RE: **National Coal of Alabama, Inc.**
Poplar Springs North Mine, P-3886, R-6

POPLAR SPRINGS NORTH
MINE, P-3886, R-6

Request for Grading Delay

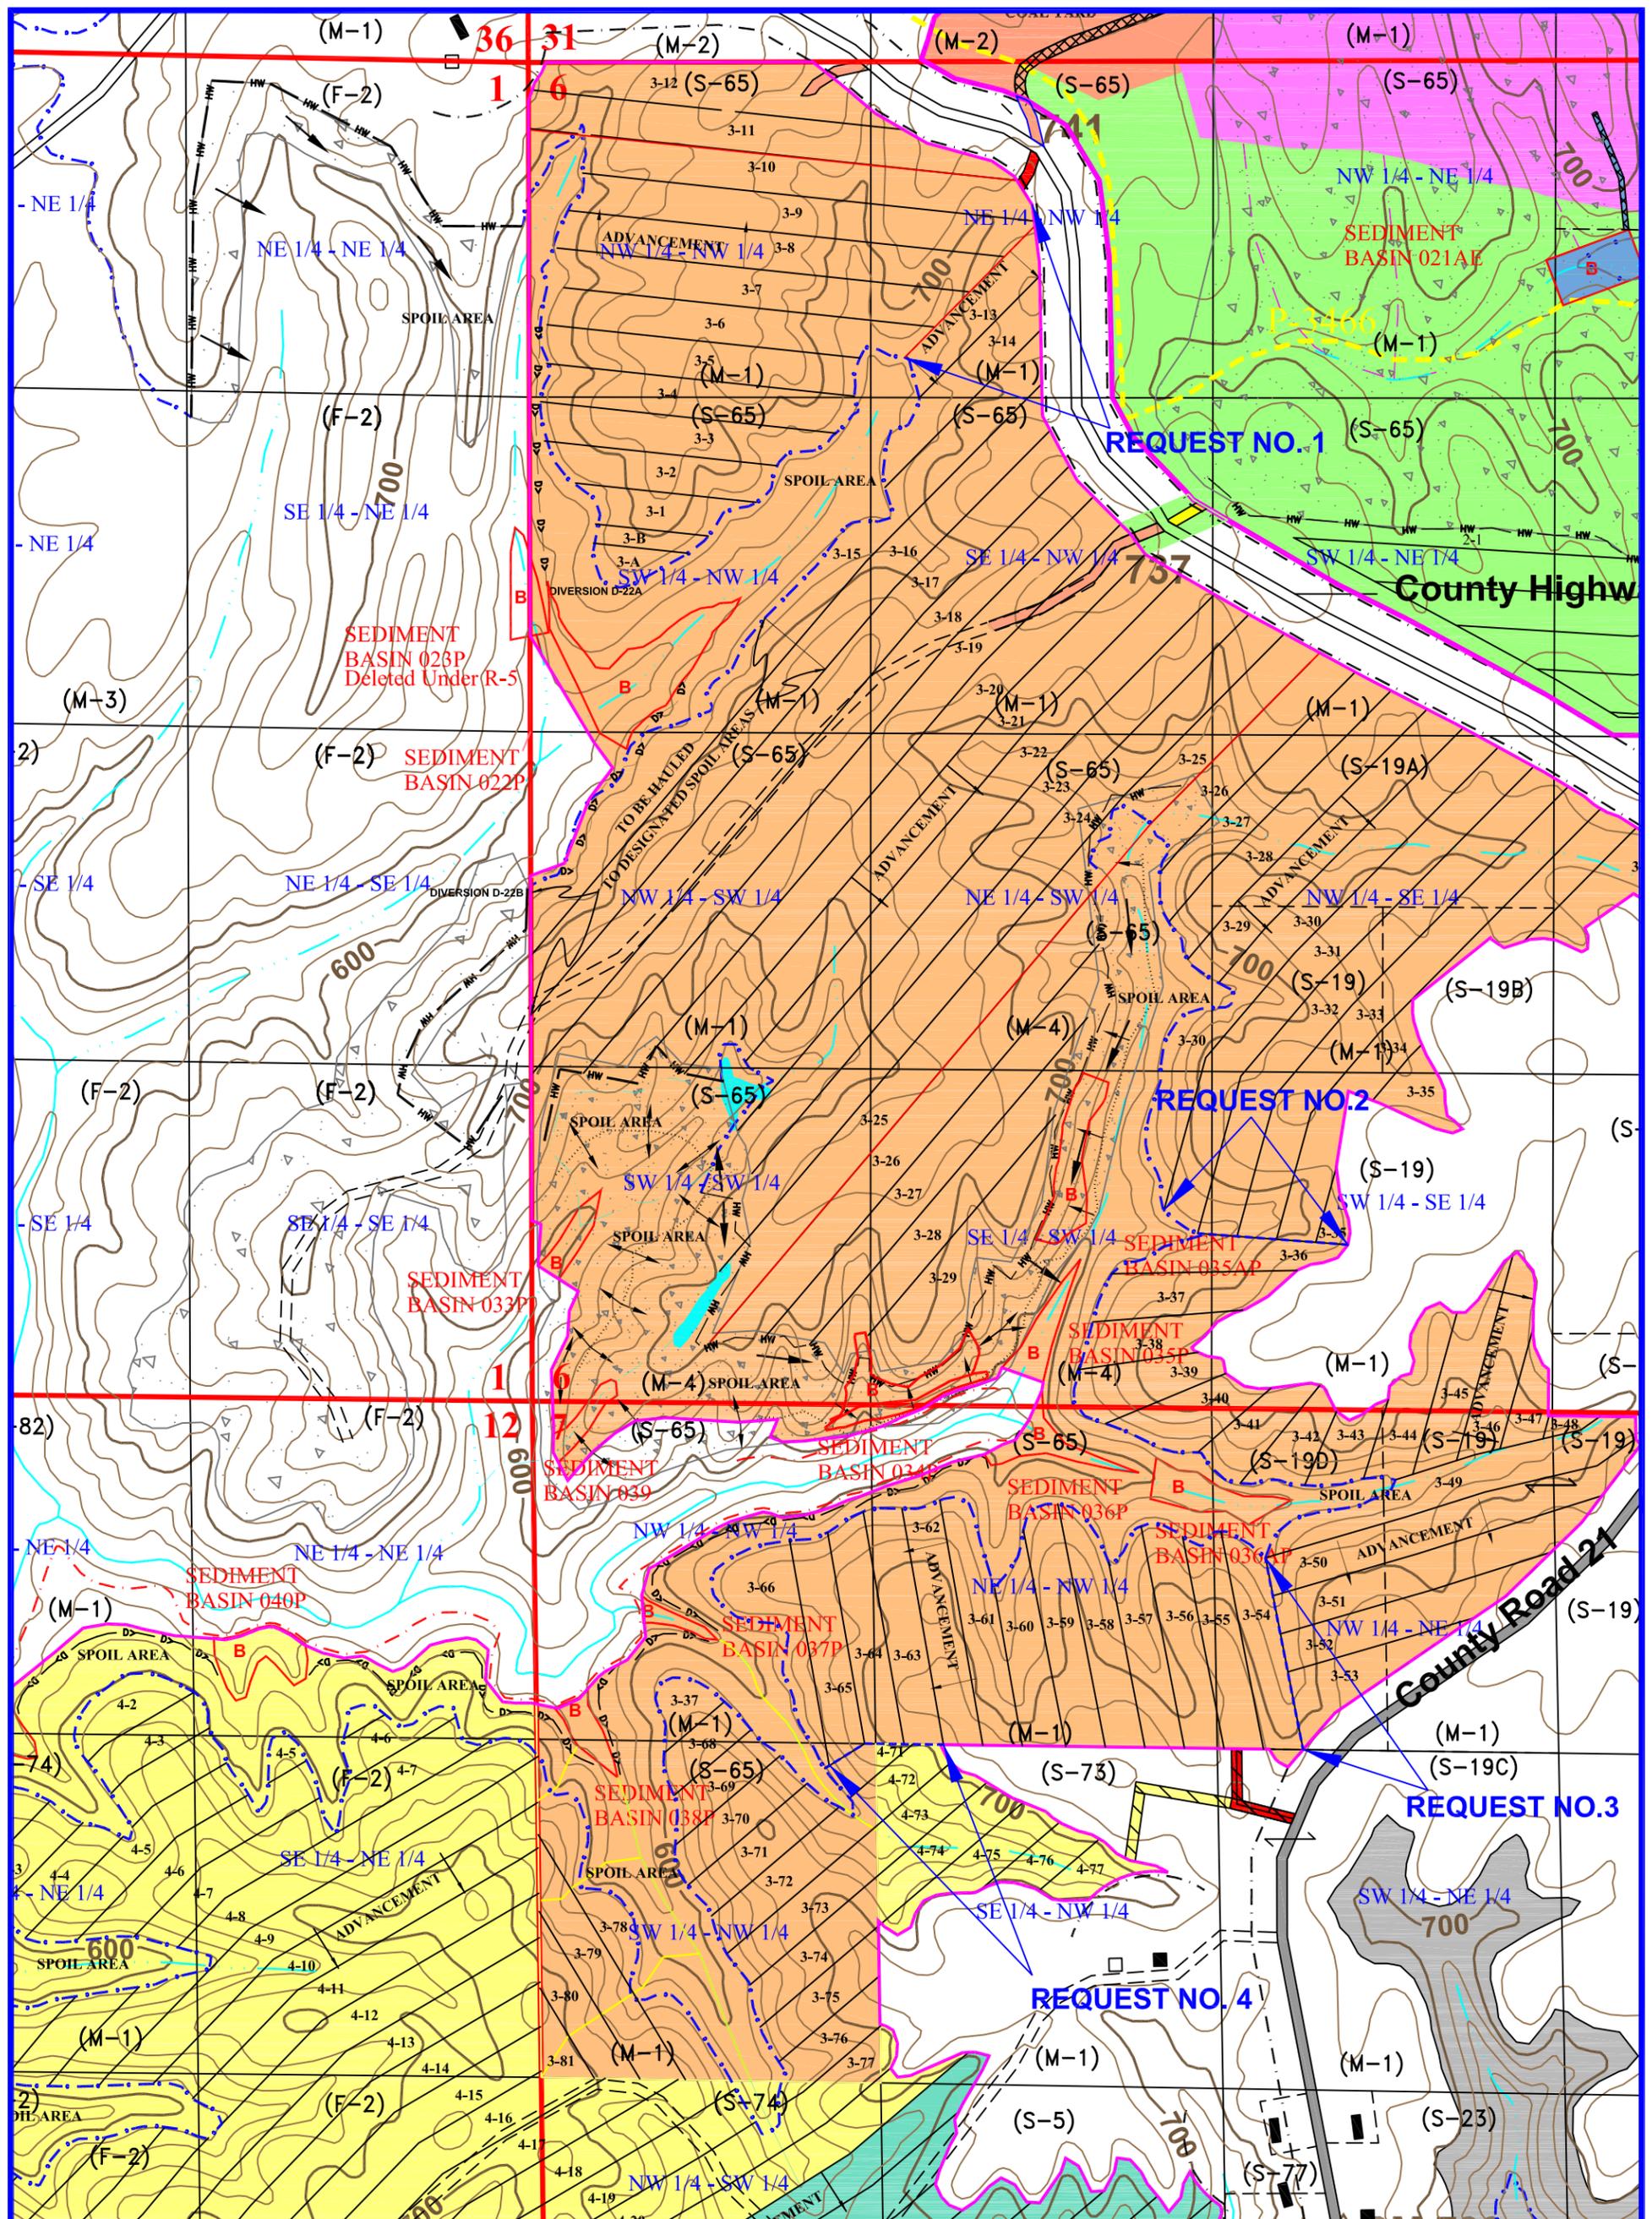
National Coal of Alabama, Inc. requests a delay in contemporaneous reclamation for a four portions of Increment No. 3.

The first request is for the southeast end of cuts 3-6 thru 3-10 to be left open for spoiling room for cut 3-13. The southeast ends of these cuts will be left open for less than three months.

The second request is for the south end of cuts 3-31 thru 3-35 to be left open for spoiling room for cut 3-36. The south end of these cuts will be left open for less than three months.

The third request is for the south end of cuts 3-44 thru 3-48 to be left open for spoiling room for cut 3-49. The south end of these cuts will be left open for less than three months.

The fourth request is for the south end of cuts 3-63 thru 3-65 and the northeast end cuts 3-72 thru 3-74 to be left open for spoiling room for cuts 3-71, 4-71 thru 4-75. Cuts 4-71 thru 4-77 are in Inc. 4 and are on property where the surface rights are currently not controlled by National Coal in the SE/NW of Section 7. Cuts 4-71 thru 4-77 will only be mined if the property is obtained.

The cuts to be left open on request number four will be open for no longer than 6 months.
